802.3ck D1.4

162C MDI Comment #43

162C MDI Comment #43

Figure 162C-3—SFP-DD cable assembly plug

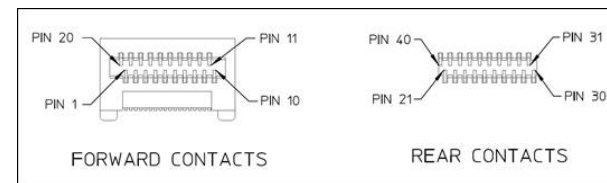
CI 162C SC 162C.2.2 P 275 L 12 # 43
 Brown, Matt Huawei
 Comment Type T Comment Status D MDI graphic (bucket1)
 The graphics in Figure 162C-3 and Figure 162C-44 are missing.
 SuggestedRemedy
 Provide graphics.
 Proposed Response Response Status W
 PROPOSED ACCEPT IN PRINCIPLE.
 Insert graphics provided in the following presentation:
 diminico_3ck_02_0120.

The SFP-DD cable assembly connector is the plug illustrated in Figure 162C-3. The SFP-DD PMD connector is the receptacle with the mechanical mating interface as illustrated in Figure 162C-4. The connectors have data signal and signal ground contact assignments as specified in Table 162C-3.
